LRW COMMENTS  
13/03/2017  
ADC.

28No. REQUIRED, AS DRAWN

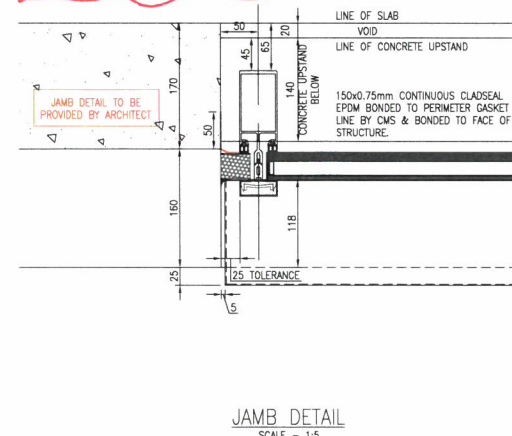
\* DO THESE WINDOWS INCLUDE THE ~~FOR~~ CERAMIC BACKED LOOK ALIKE GLAZING PANEL (COLOUR RAL 1019)? (IN FRONT OF THE CONCRETE PANELS.)  
THE CURTAIN WALLING PANELS / WINDOWS NEED TO INCLUDE THIS AS PER LRW ARCHITECTS DESIGN. - SEE LRW DWGS 7459 L(24) 02B, 03B, 07, L(20) 10E, 11E.
